Grants Reclamation Project

Homestake Mining Company of California

Re: Reply to "Request for Additional Information – Compliance of Homestake Grants, New Mexico Site with 10 CFR 20.1301 and 10 CFR 20.1302." Docket No. 040-08903, License No. SUA-1471

Preface

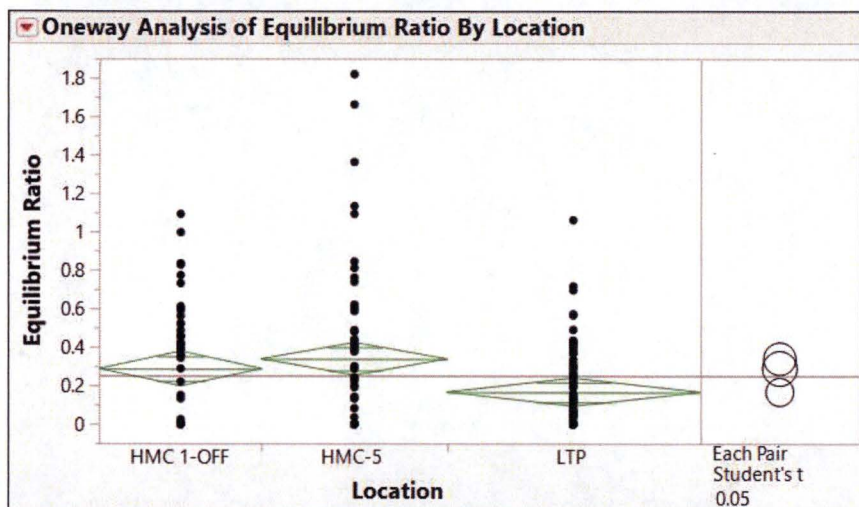
The NRC staff requests that HMC commit to computing the dose limit where the dose conversion factor is based on the air radon concentration of 10 CFR Part 20 Appendix B, Table 2, with daughters and appropriate equilibrium ratios or provide justification as to why radon concentration without daughters is acceptable. Additionally, it is requested that HMC provide equation(s), equilibrium ratios, occupancy factors, and any other factors it considers appropriate to the NRC staff to demonstrate compliance with the public dose limits and provide any justifications for any changes for future submittals of environmental monitoring reports. These parameters, along with calculated radon release rates from the tailings, can be used in the MILDOS program to compute radiation doses to members of the public.

In the Basis for Request provided by NRC for RAI #4, the NRC cites an equilibrium ratio of 0.34 at air monitoring station HMC-5 based on calculations using MILDOS modeling output data provided by HMC. HMC recently conducted a study with direct measurements of radon equilibrium ratios at select

locations, including the LTP, HMC-5, and HMC-1OFF (an upgradient air monitoring location assumed representative of background conditions along the floor of the San Mateo Creek drainage). Respective measurements included short-term grab sampling for radon gas (with a DurrIDGE RAD7 instrument) and measurement of radon progeny based on air grab sampling and analysis of sample filters using the modified Kusnetz method. These paired measurements, co-located in time and space, were scheduled twice per day (morning and afternoon) three days per week over a study period of approximately 4 months. Details of the methods and sampling design were provided in an associated Study Plan (ERG, 2017). Interim study results were provided to NRC for review during the March 2018 Site Inspection (ERG, 2018). Complete study results are currently being compiled in a final report that will be available for NRC review at the September 2018 Site inspection (as requested by NRC at the March 2018 inspection). The distribution of calculated equilibrium ratio results reveals a mean value of 0.34 at HMC-5, coincidentally matching the value calculated by NRC for this location (see NRC Basis for RAI #4). As might be expected, measured equilibrium ratios on top of the LTP are statistically lower than other locations as radon emissions from the LTP are “fresh”, consisting only of radon gas when first released from the soil surface.

Because measured equilibrium ratios vary considerably (temporally and spatially) and the Study period was limited (about 4 months), and since there is uncertainty in both direct measurement and modeling of equilibrium ratios, HMC proposes to use conservative generic values specified by NRC to be generally acceptable as noted above. The nearest member of the public represents a residential scenario with combined indoor/outdoor exposures, and a radon equilibrium ratio of 0.5 will be used in MILDOS

modeling for future estimation of public dose from radon gas/progeny. Results will be reported annually in 2nd half semiannual 40.65 reports.

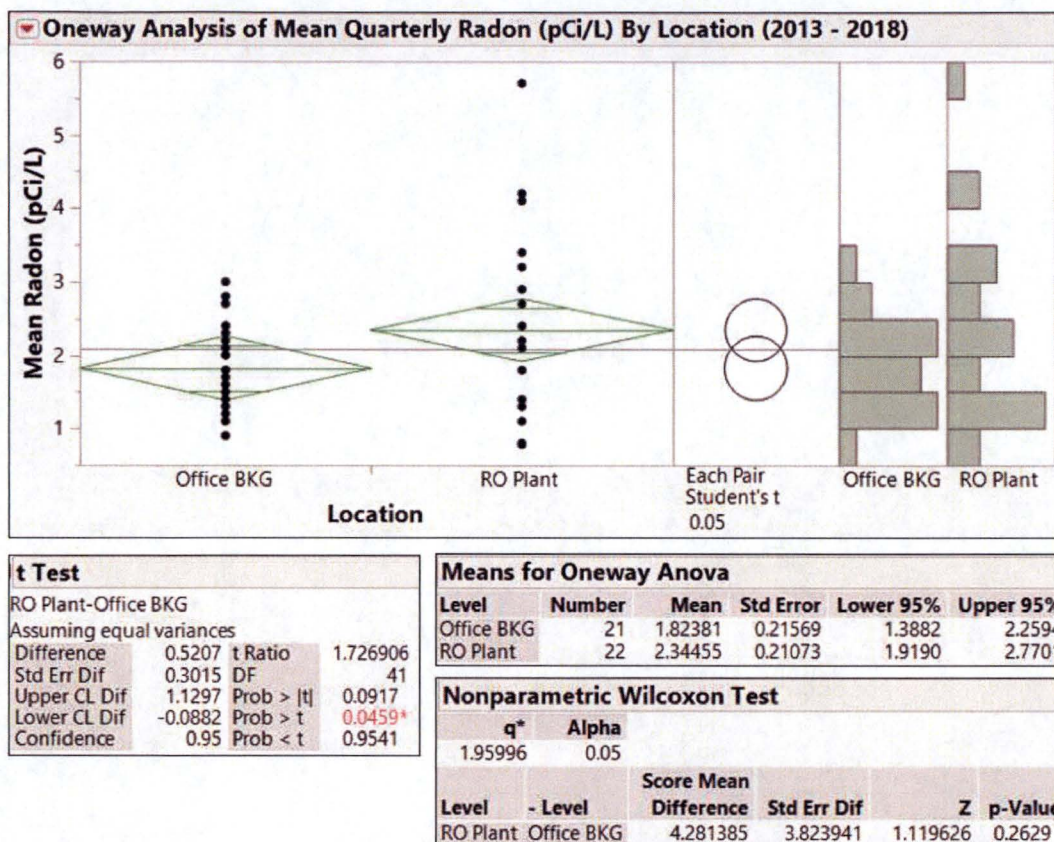
The NRC staff requests that HMC demonstrate, preferably by measurements from the main release point of the water treatment system, and not at some distant environmental monitoring station receptor point that the radon releases are insignificant.

As indicated in the 1st half 40.65 report for 2018, estimated annual releases of radon gas from the LTP and STP are 694 and 88.7 Ci, for a total of 783 Ci. For the RO plant, an estimate of the release of radon to the outside atmosphere due to groundwater treatment in the RO building can be calculated as follows:

The total annualized ventilation rate for the RO building is estimated to be 1.12E+12 L/yr (based on summation of flow rates for all exhaust fans). A statistical comparison of quarterly average radon gas concentrations measured in the main office building and in the RO building over the past 5 years is

shown in the below figure. The main office is considered representative of background indoor radon levels for onsite buildings. The net difference in these average values (0.52 pCi/L) is assumed due to RO treatment of groundwater containing 11e.(2) byproduct material. Based on these parameters, the calculated release of radon gas from the RO plant is 0.6 Ci/yr, less than 0.1% of total radon effluent releases from the tailings piles in 2018.
